RE: NEF-111jdw, 90V-040

This is in response to your March 15, 1990 request for additional information concerning Toyota's NHTSA Recall Campaign Number 90V-040.

1984 Camry Cruise Control Computer Investigation Report

Fig 4 No.3 Terminal Repair

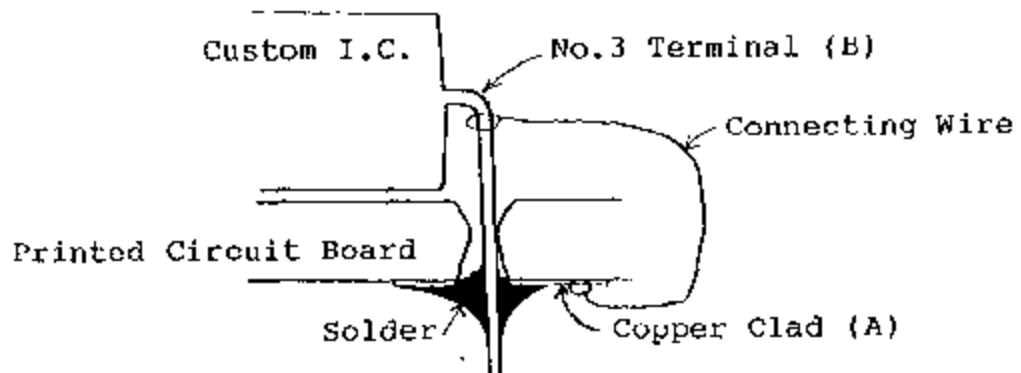
This means that the open circuit mode occurred in the soldering portion on the No. 3 terminal of the custom I.C..

To confirm whether the cause of this failure mode is the open circuit on the No. 3 terminal or not, we measured the voltage level at each terminal by connecting the copper clad (A) and the No.3 terminal (B) using another wire as shown in Fig. 4.

Consequently, the voltage level at each terminal was the same as that of the normal part and the computer performed all functions properly. Test results are included in table 4 through 7.

Photo 6 Cross Section Cut-Away of No.3 Terminal
(Yves Arcouet Case)

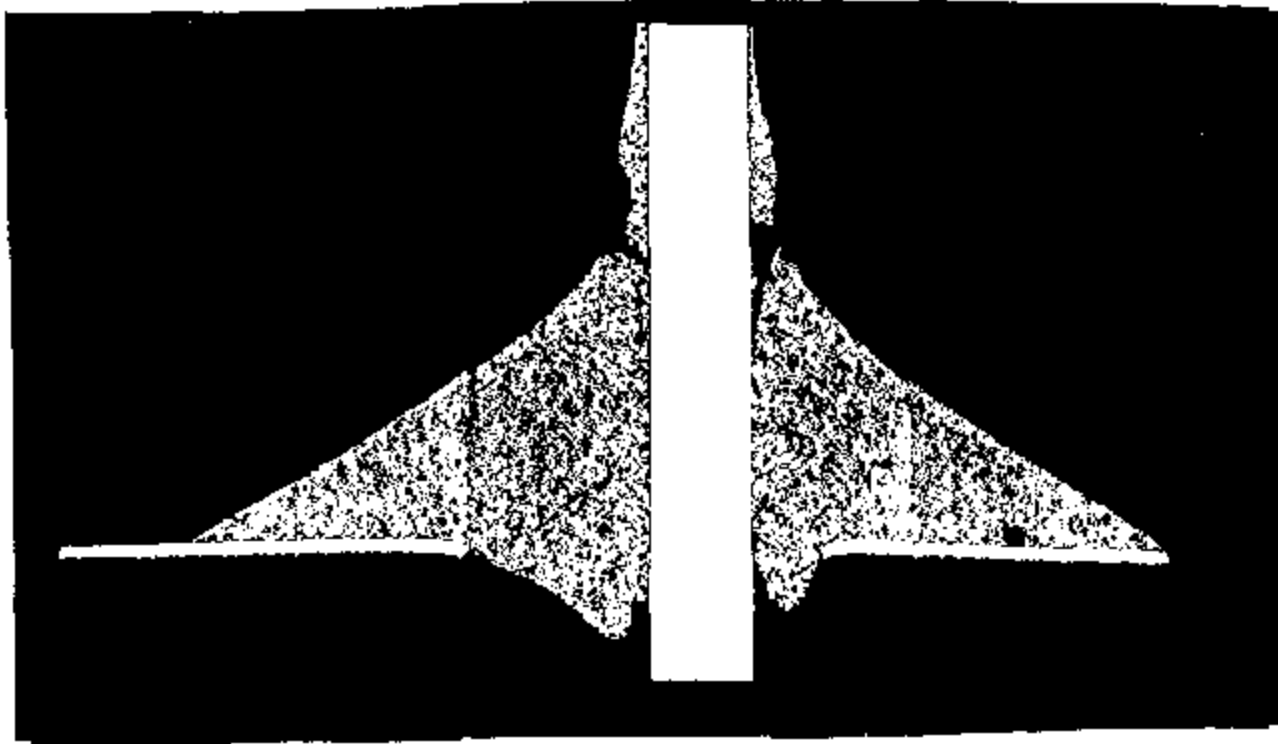
With microscopic observation of the soldering portion on the No.3 terminal of custom I.C., it was found that the solder was fractured along the terminal as shown in Photo 6 and 7.

Based on the aforementioned results, we have concluded that the failure mode for both computers was caused by the open circuit due to a solder fracture on the No.3 terminal of the custom I.C..

Fig. 1 Test Method

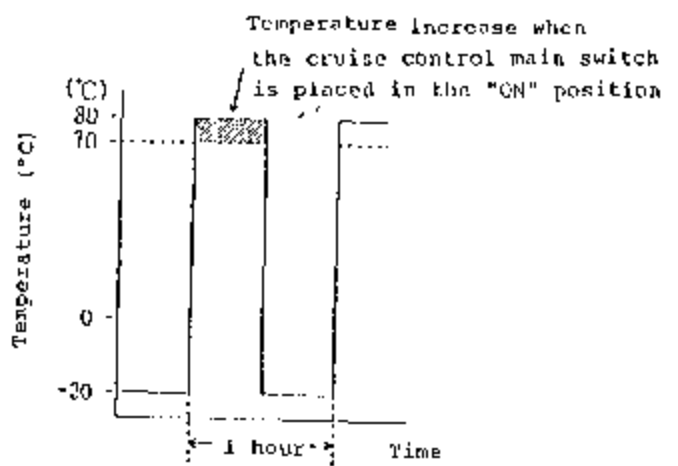
Thermal shock test was conducted for the subject computer using the cycle shown in Fig.1, which was used during the development stage.

As a result, there were no abnormalities as shown Fig.2.

Fig.3 Temperature increase of Subject Computer

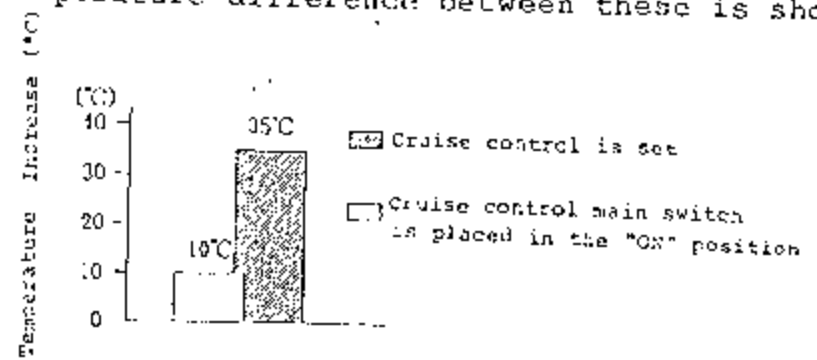
Thereupon, based on the fact that the cruise control computer failures occurred in Canadian vehicles only, we conducted a detailed investigation focusing on the temperature. As a result, we found that the surface temperature of the custom I.C. when the cruise control was set, is higher than when the cruise control main switch only is placed in the "ON" position, which is the test condition during development. The temperature difference between these is shown in Fig.3.

Fig. 4 New Test Method

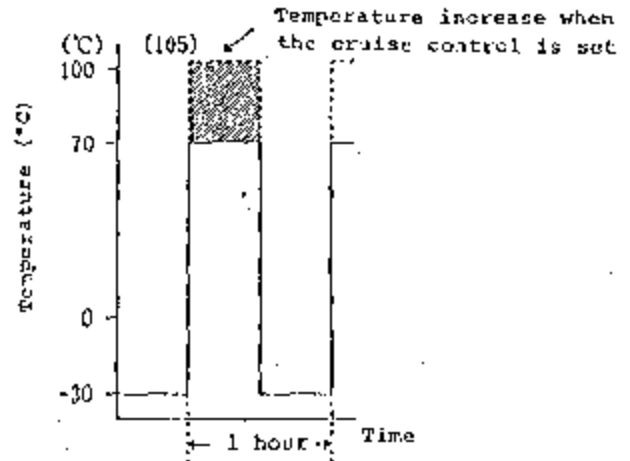
Fig.5 shows the test results. Cracks were found on the soldered terminal of the custom I.C. at 50 to 80 cycles and the soldered portion was fractured at 110 to 140 cycles.

Fig. 6 Stress on the Soldered Portion

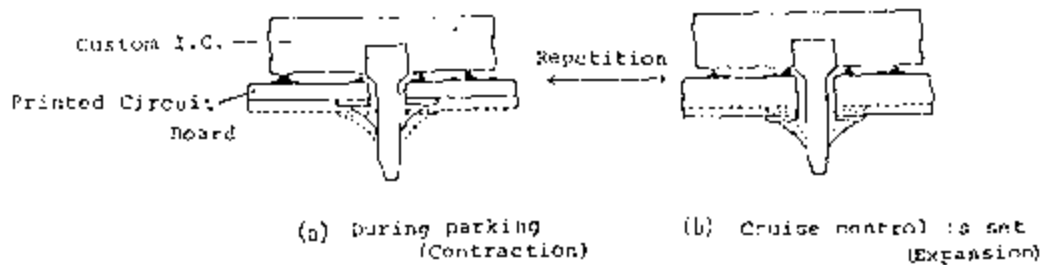
We found the temperature increase by self-generating heat from the custom I.C. is higher than that expected during development. The soldered terminal is stressed by contraction/expansion of the printed circuit board and custom I.C. due to repetition of excessive thermal shock (See Fig.6). It could cause the soldered terminals of the custom I.C. to develop cracks and finally may lead to a complete separation of the soldered terminals, resulting in non-conductivity of the circuit.

Fig 4 No.3 Terminal Repair

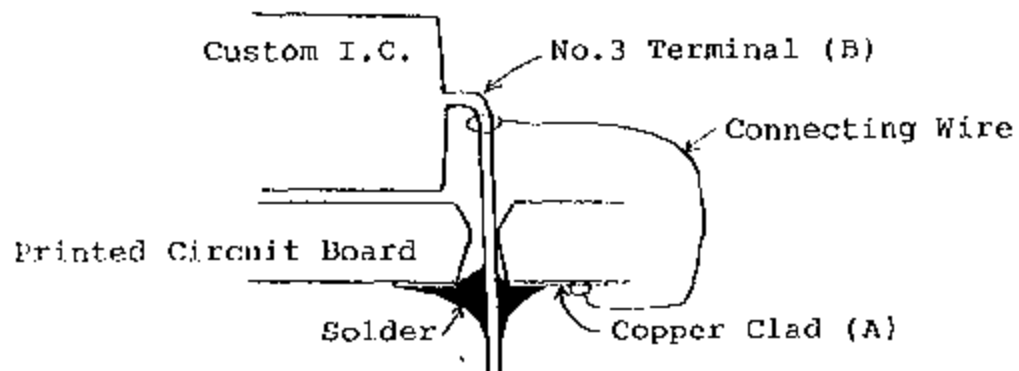
Consequently, the voltage level at each terminal was the same as that of the normal part and the computer performed all functions properly. Test results are included in table 4 through 7.

Photo 6 Cross Section Cut-Away of No.3 Terminal
(Yves Arcouet Case)

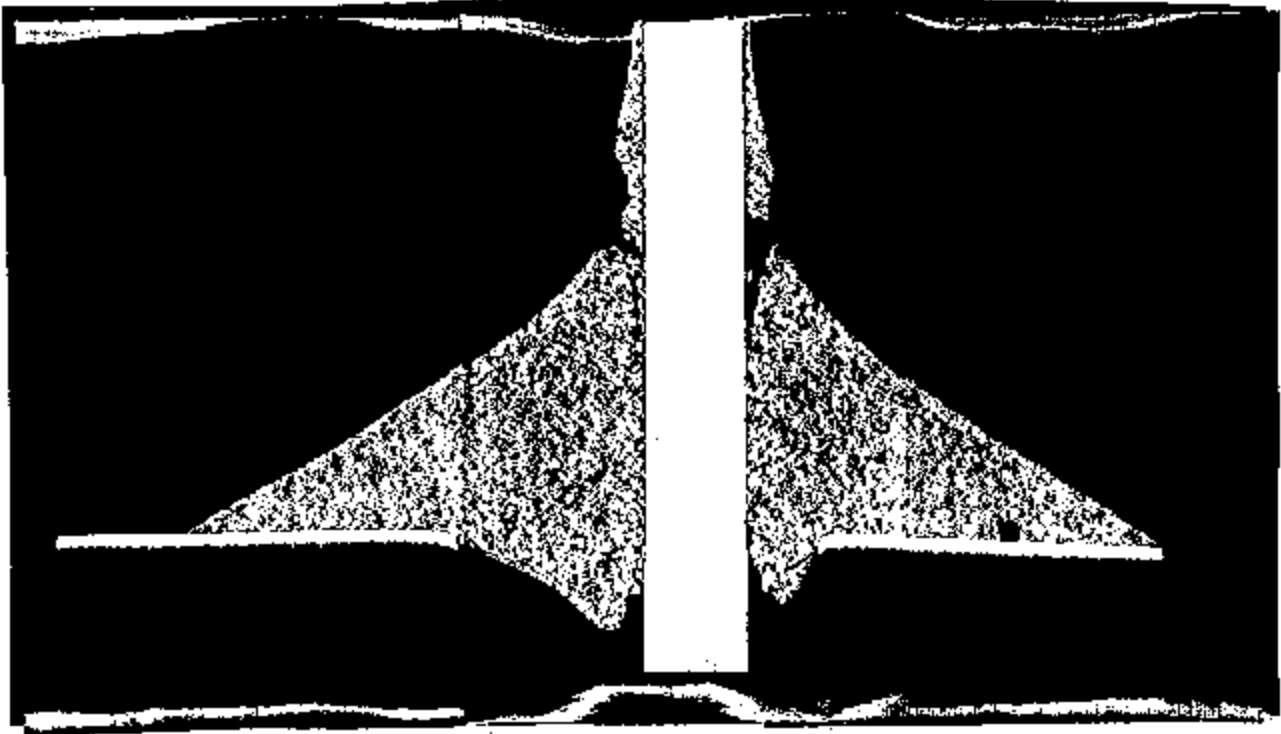
With microscopic observation of the soldering portion on the No.3 terminal of custom I.C., it was found that the solder was fractured along the terminal as shown in Photo 6 and 7.
